**CORRECTIONS TO THE DRAWINGS**

### REMARKS

*Corrected Drawings  
(w/ Markups)*

Fig. 1D2

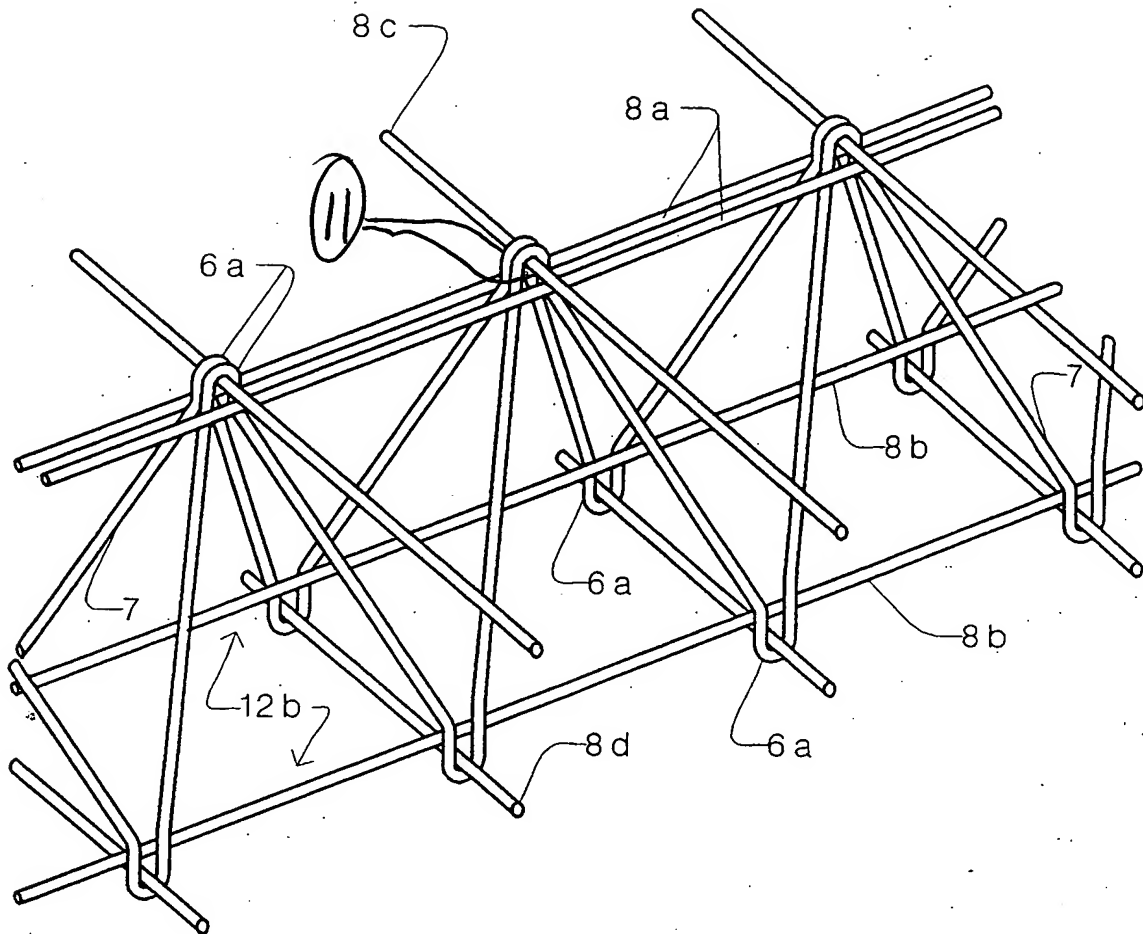
Submitted herewith are replacement/corrected drawings by which the issues with respect to characters “8” and “18” are believed addressed. Additionally, the amendments to the specification made herein have included proper reference to reference numbers 8e and 8f; have removed the reference to non-existent Figs. 1H; and have corrected the reference to Fig. “1D” with proper reference to Figs. “1D1” and “1D2”. Accordingly, the drawings are now believed to be in proper condition.

Fig. 3J

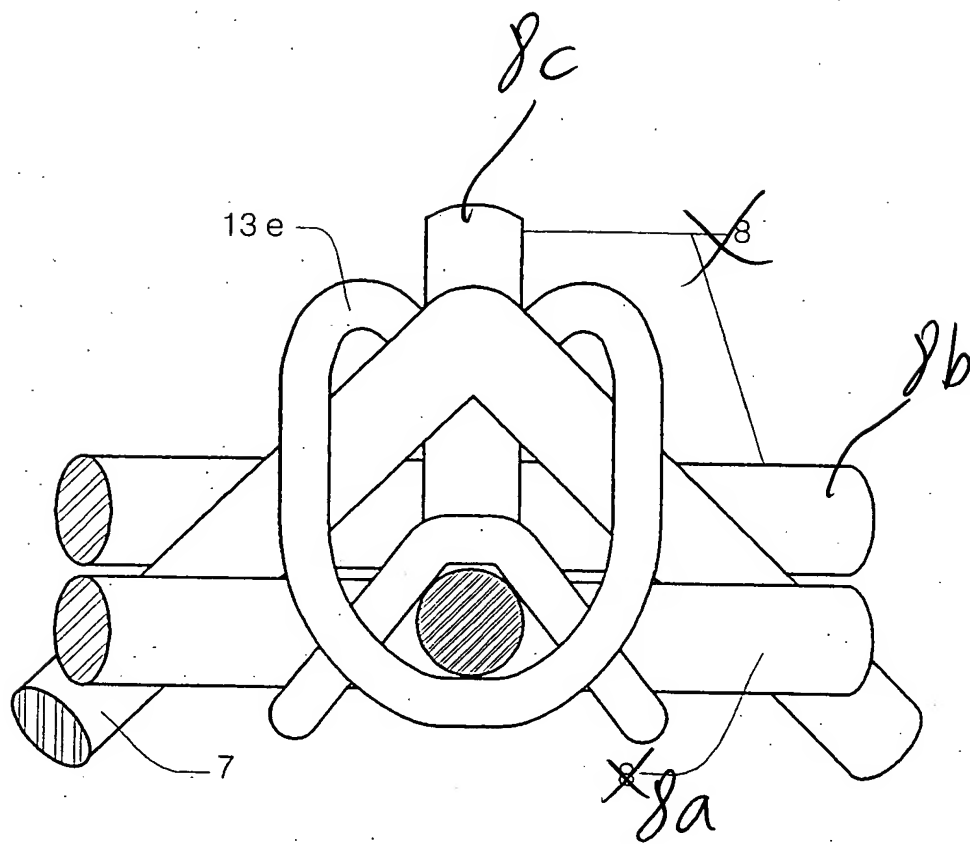
The Drawings were objected to because reference characters "18" and "8" were both used to refer to cord elements (Figs. 5A), because the reference character "8" was used to designate both cords and cross reinforcement elements (Figs. 3J, 3K, 3L, 4B,
